From: Tai, Tom
Sent: Monday, April 04, 2011 4:02 PM
To: Price, John E
Cc: STPCOL; Wunder, George; Tonacci, Mark
Subject: Wed Call - Clarification on March 14 2011 Audit Actions
Attachments: Clarification on March 14 2011 Audit Actions.docx

Subject: Wed Call - Clarification on March 14 2011 Audit Actions
Sent Date: 4/4/2011 4:02:05 PM
Received Date: 4/4/2011 4:02:07 PM
From: Tai, Tom

Issue 8: Stability Analysis Procedure

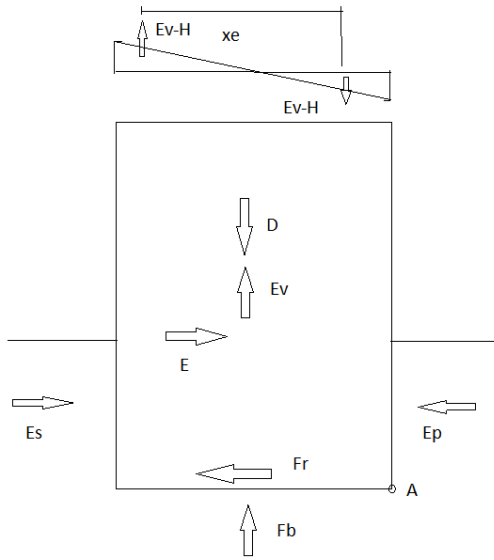
A brief presentation of the stability analysis procedure was made by the applicant during the March 14, 2011 audit. The presentation included a rigid body diagram showing the forces acting on the structure for stability calculations. The applicant indicated that the total seismic demand is calculated by summing all the inertia forces and moments acting on the structure. These inertia forces are calculated by multiplying the mass of each node by the absolute value of the maximum acceleration response at that node obtained from the SSI analysis. The calculation of the seismic overturning moment is based on the horizontal seismic load E and vertical seismic load E_v about tipping point A, as shown in the figure below. The moment due to horizontal earthquake does not include E_{v-H} (vertical force due to horizontal input) which also produces overturning moment about A. The applicant is requested to provide justification for not including the vertical component of response due to horizontal seismic input in calculating the foundation overturning moment.
